State of New Mexico
Energy, Minerals and Natural Resources

Form C-103
Revised July 18, 2013

WELL API NO. 30-015-36577
5. Indicate Type of Lease STATE <input checked="" type="checkbox"/> FEE <input type="checkbox"/>
6. State Oil & Gas Lease No.
7. Lease Name or Unit Agreement Name GUARDIAN 25 STATE COM
8. Well Number 1
9. OGRID Number 6137
10. Pool name or Wildcat ARTESIA;BONE SPRING
11. Elevation (Show whether DR, RKB, RT, GR, etc.) 3501' KB; 3484' GL; 17' KB to GL

PROPOSED PLUG & ABANDONMENT

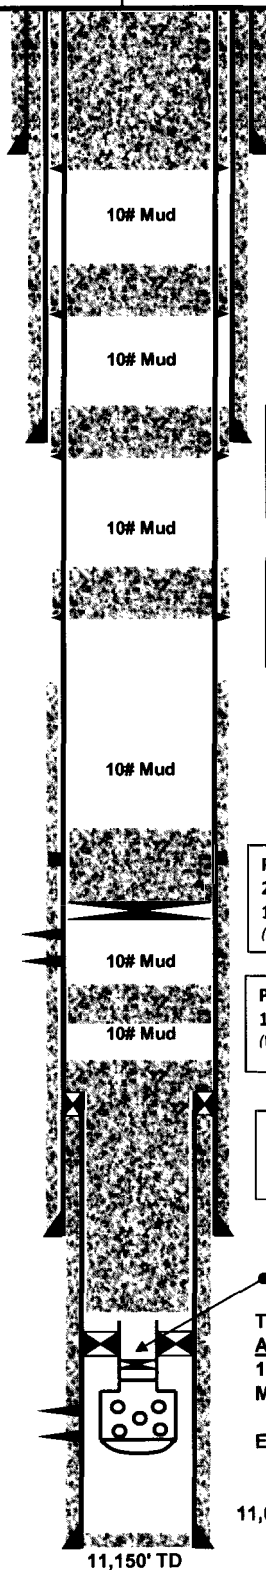
- MIRU P&A Unit.
- POOH w/2-3/8" N80 production tubing and Arrowset packer from 7,932'. Circ out sand and retrieve RBP @ 8,075'. *woc + Tag*
- Spot ~~120~~ 25 sx Cl H cement @ 10,820' - ~~9,555'~~ Tag TOC. Circulate wellbore w/10# salt gel mud. *25sks 10820 - 10700*
- Spot 25 sx Cl H cement @ 8,460' - 8,340'. *Part @ 10130 Sge 100sks Cl H woc + Tag*
- Set CIBP @ 7,950'. Spot 50 sx Cl H @ 7,950' - 7,705'. Tag TOC.
- Perf @ 4,705'. Pump 45 sx Cl C in/out @ 4,705' - 4,545'.
- Perf @ 3,305'. Pump 50 sx Cl C @ in/out @ 3,305' - 3,130'. Tag TOC.
- Perf @ 1,465'. Pump 50 sx Cl C in/out @ 1,465' - 1,290'. Tag TOC.
- Perf @ ~~540'~~ 540'. Pump 155 sx Cl C in/out from 540' to surface. *Part 508*
- Cut wellhead off 3' bgl. Set dry hole marker.

** See Attached COA's Must Be Plugged by 11-14-18*
I hereby certify that the information above is true and complete to the best of my knowledge and belief.

APPROVED BY: [Signature] TITLE Staff Mgr DATE 11-14-17
Conditions of Approval (if any):
